Prairie Island Nuclear Generating Plant

**Response to Request for Additional Information Concerning the Prairie Island
Nuclear Generating Plant Request for Exemption from 10 CFR Part 50,
Appendix R, Section III.G.2, "Fire Protection of Safe Shutdown Capabilities"**

Response to Request for Additional Information Concerning the Prairie Island Nuclear
Generating Plant Request for Exemption from 10 CFR Part 50, Appendix R, Section
III.G.2, "Fire Protection of Safe Shutdown Capabilities"

DATE: 5/30/97	DRAWN BY: R.J. RAVERTY
PROJECT: E94L483-G	
A/E: NSP	REV # 2
CONDUIT LAYOUT	SKETCH # 9704501-1

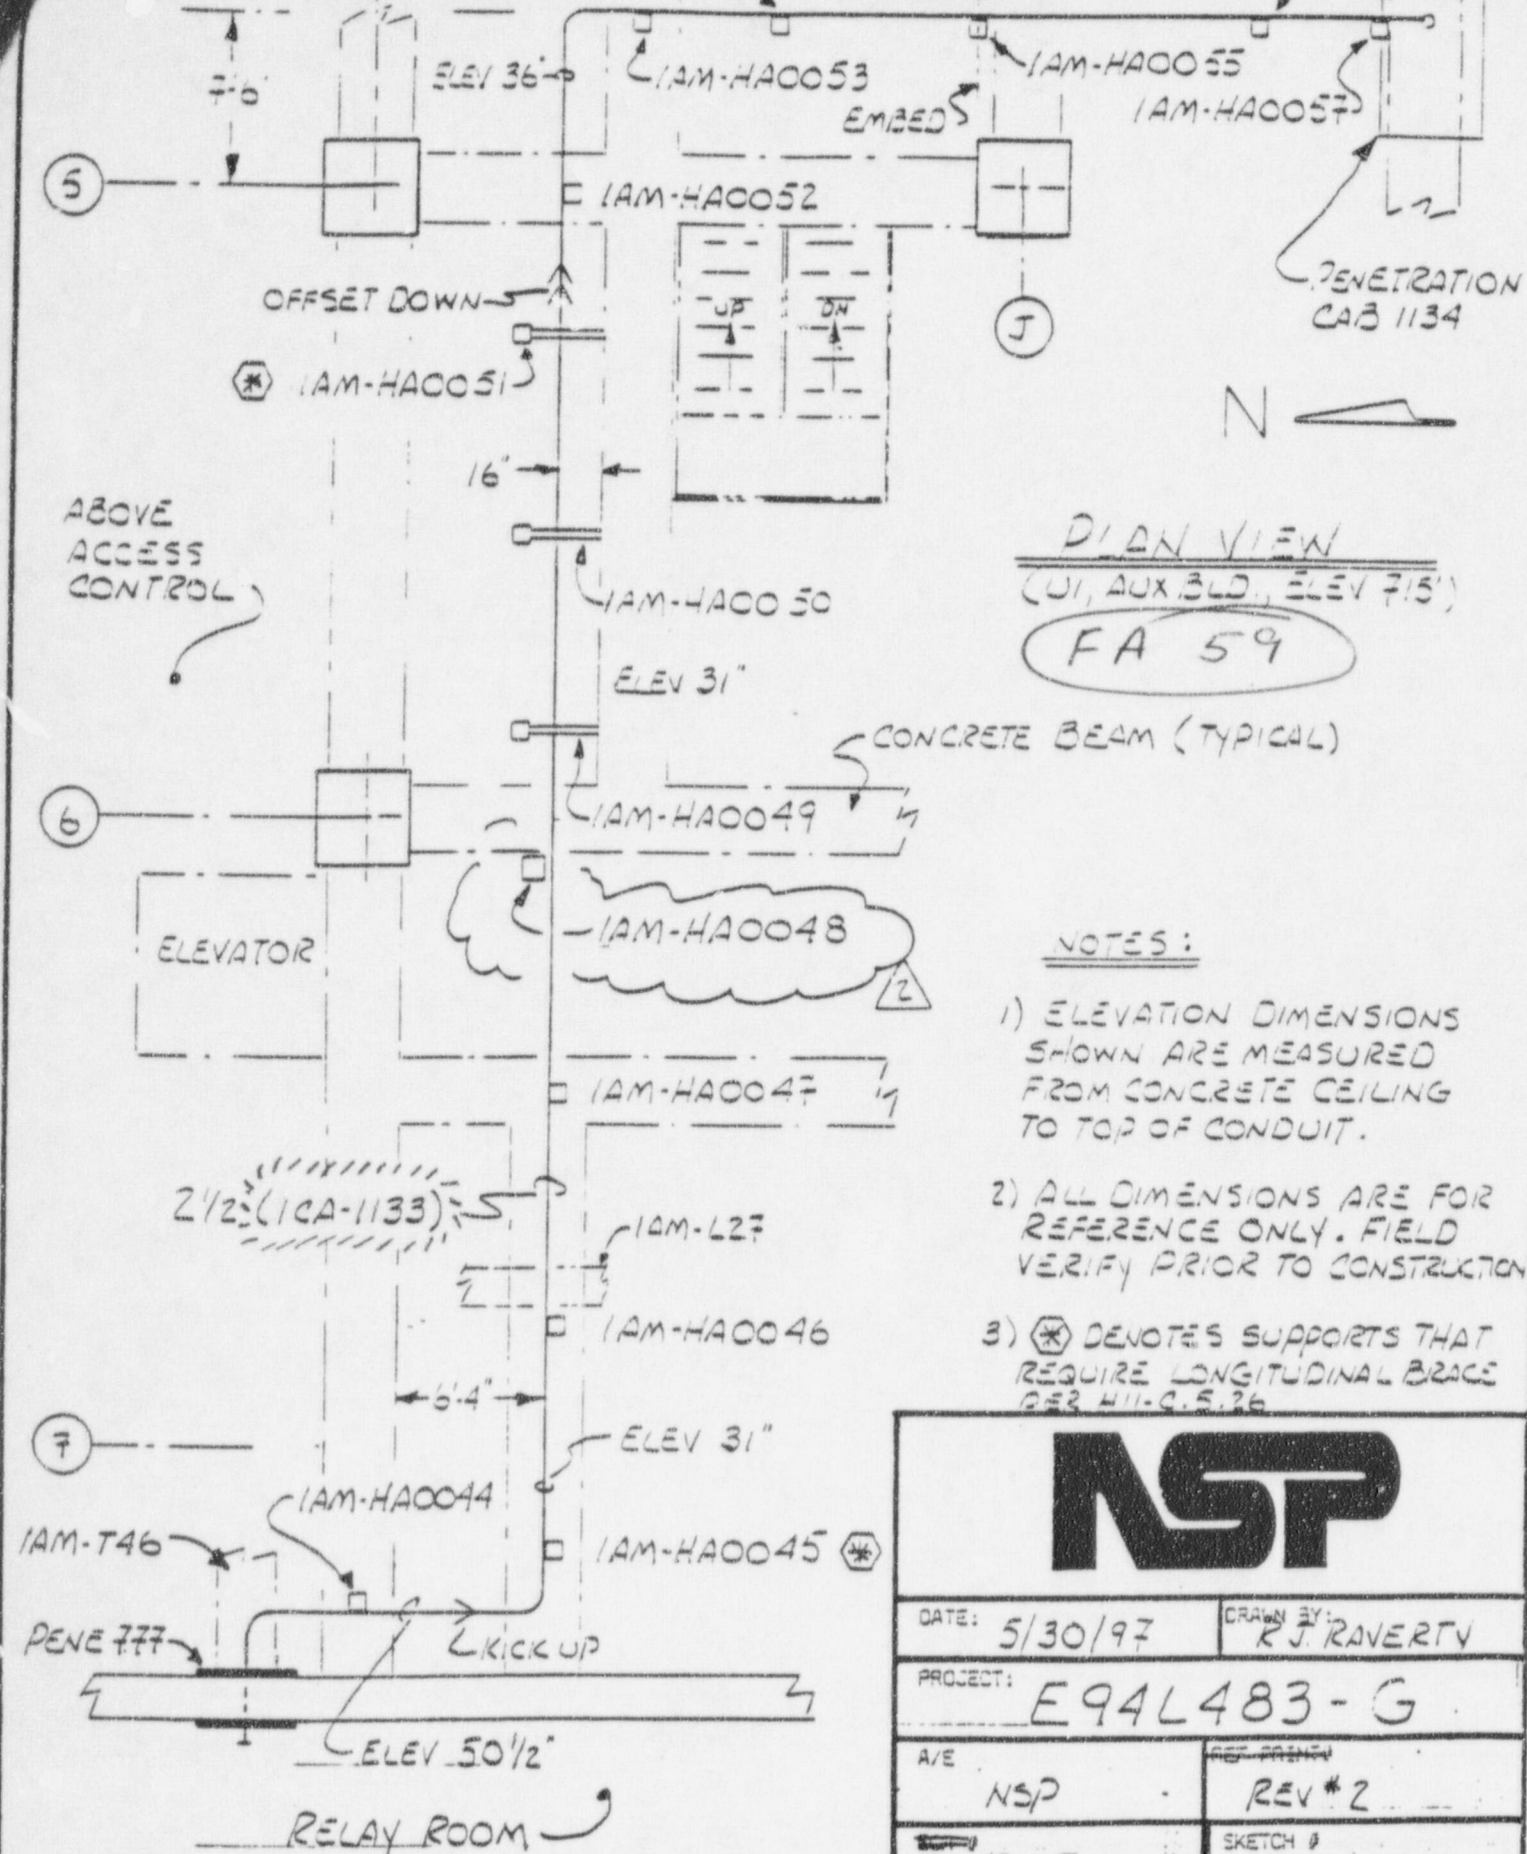
Question 1: *Provide detail drawings or diagrams that depict the routing of the Firezone R cables and the basic features (equipment, storage, components, etc.) of the fire areas through which the Firezone R cables will pass. Provide a detailed description of the configuration that the Firezone R cable will be in, the type of the cable (e.g., 3C14 AWG), and the expected service loads that will be required of the cables (voltage and current). State the function of each cable, i.e., power, control, or instrumentation.*

Refer to attached installation detail drawings associated with each installation of the Rockbestos Firezone R cable [Attachment 2]. Each cable is installed in steel conduit through the fire area of concern. For clarity and greater detail, the approximate routing is also sketched on area layout drawings [Attachment 3]. Any potential future use of Firezone R cable in these areas as well as other areas for which exemption is requested is presently undefined.
